Rampion 2 Wind Farm Category 8: Examination Documents

Applicant's Responses to South Downs National Park Authority Deadline 1 Submissions

Date: March 2024
Rev A

Application Reference: 8.47
Pursuant to: The Infrastructure Planning (Examination
Procedure) Rules 2010, Rule 8(1)(c)(i)
Ecodoc number: 005118963-01

Fig. 2 – Extract from South Downs Integrated Landscape Character Assessment (2020) – Area affected Onshore

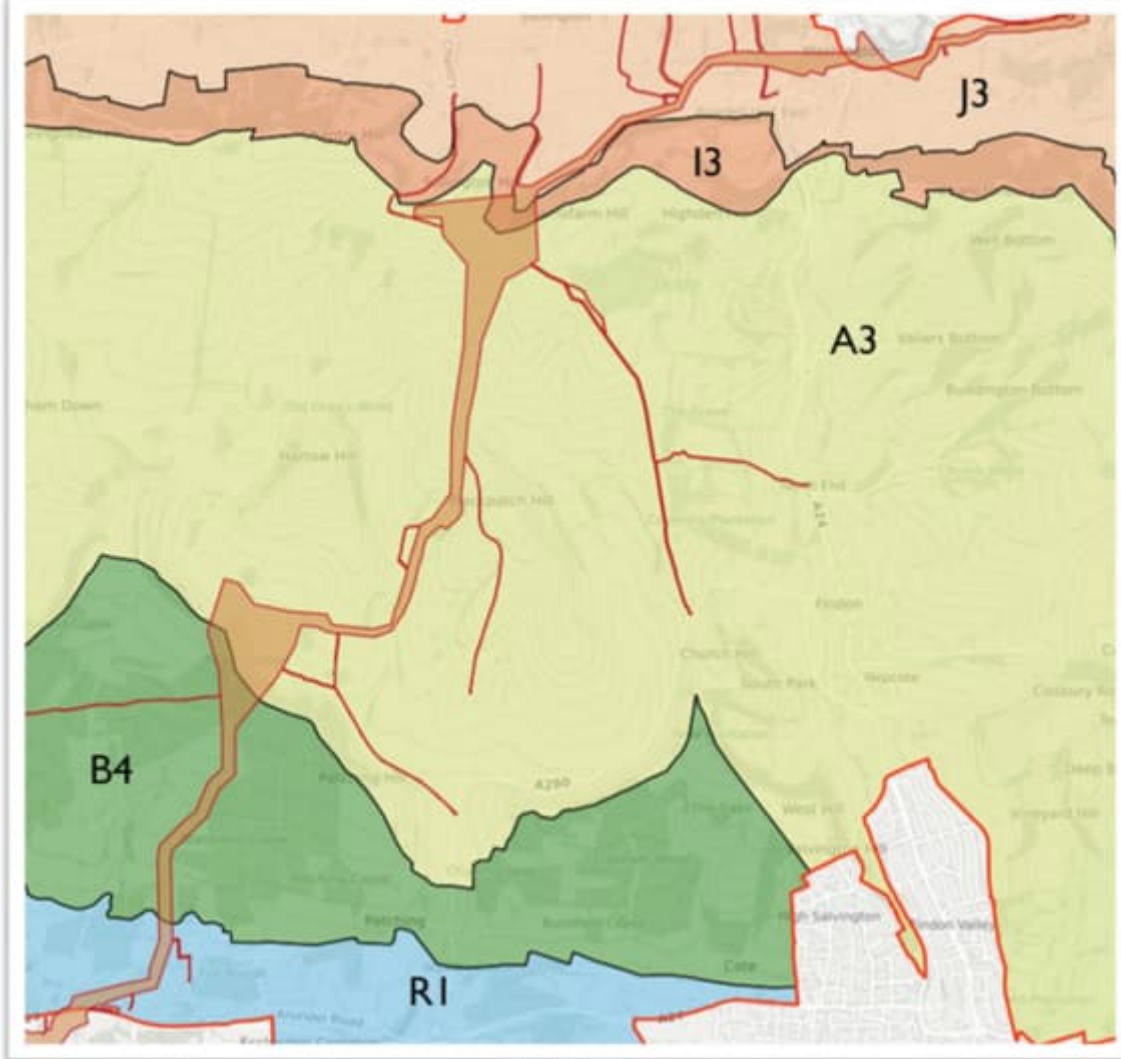
<p>5.12</p>	<p>5.12 SDILCA defines 19 general landscape types within the National Park as well as 55 more place-specific 'character areas'. The proposed cable corridor is within 5 general landscape types, namely Open Downland, Wooded Estate Downland, Major Scarps, Scarp Foothills and Upper Coastal Plain; and more specifically, A3 – Arun to Adur Open Downs, B4 – Angmering and Clapham Wooded Estate Downland, I3 – Arun to Adur Downs Scarp, J3 – Arun to Adur Scarp Foothills and R1 – South Downs Upper Coastal Plain. As shown for the National Park in Figure 2 below with 11 the DCO limits shown shaded orange and running broadly north-south.</p>

Fig. 5 Scheduled Monuments in relation to Cable Corridor

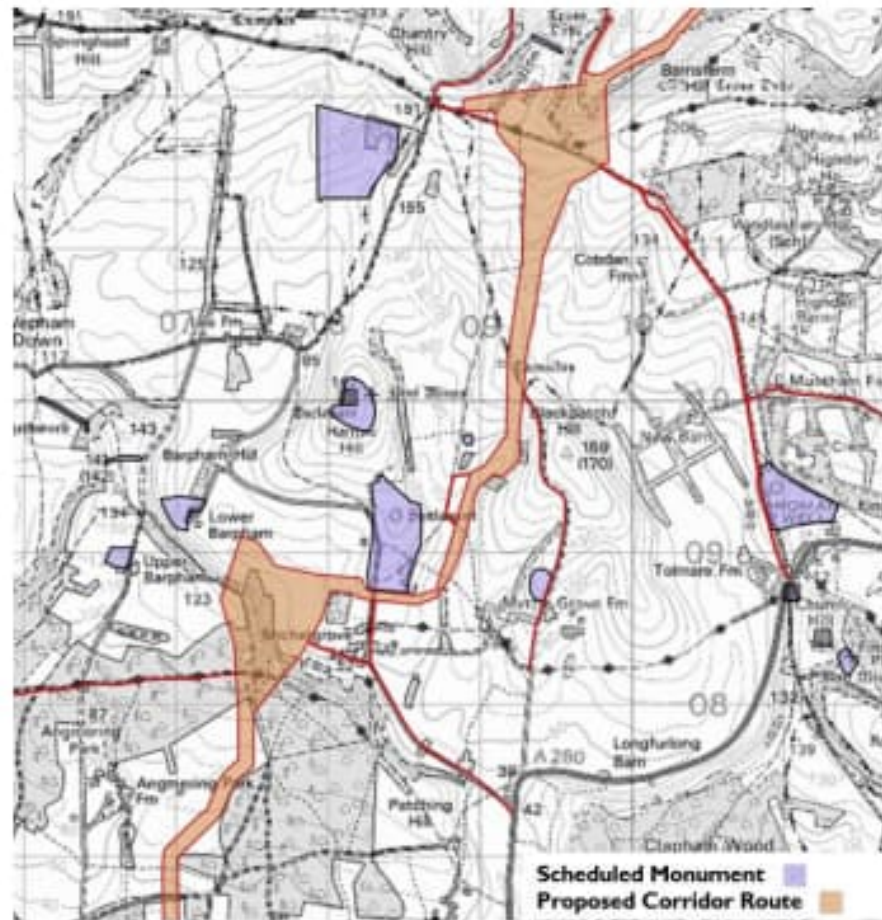
Ref	Written Impact Report Comment	Applicant's Comment
3.10.2	3.10.2. The proposed route of the cable corridor would come in close proximity to a Scheduled Monument (Itford Down) and through an area of known prehistoric industrial activity (see Fig 5).	<p>evaluation techniques within the part of the proposed DCO Order Limits which falls within archaeologically sensitive areas within the South Downs National Park. The Outline Onshore WSI [APP-231] (secured by Requirement 19 of the Draft DCO [PEPD-009]) provides for the production of site-specific WSIs which will set out the requirements for further investigation where this has not been completed pre-DCO consent. The results of these further investigations will underpin the subsequent design and amendments as required to avoid and/or mitigate harm to heritage assets. The site-specific WSIs will also set out mitigation measures to secure archaeological recording and reporting where an avoidance is not possible. Engagement is ongoing with relevant stakeholders to provide comment/input to the Outline Onshore WSI [APP-231] which will be updated during the Examination.</p> <ul style="list-style-type: none"> In the absence of baseline evidence from recommended evaluation techniques being undertaken pre-DCO Application, the assessment of historic environment effects presented in Sections 25.9 to 25.12 of Chapter 25: Historic environment, Volume 2 of the ES [PEPD-020] considers a worst-case scenario. The potential for nationally significant archaeological remains has been identified within part of the proposed DCO Order Limits which crosses the SDNP. <p>The historic environment baseline presented in Chapter 25: Historic environment, Volume 2 of the Environmental Statement (ES) [PEPD-020] and in Appendix 25.8: Onshore heritage asset baseline report, Volume 4 of the ES [APP-214] identifies these heritage assets.</p>

3.10.3 3.10.3. Blackpatch and Harrow Hills sit on high points either side of the valley containing the proposed route corridor. Given both sites are of a prehistoric industrial nature, it is probable that the valley contains significant potential for settlement evidence from the early prehistoric (and therefore may represent some of the earliest evidence for Neolithic settlement in Britain). The landforms themselves suggest significant sediment build ups within the dry valley between both sites, with potential evidence for Neolithic and other periods lying deep in the valley profiles. This means that geophysical data, which is all that has informed this section of the route (to date) is unlikely to provide a sufficiently detailed evidence base on which to base decisions relating to route options (Document Reference APP-066).
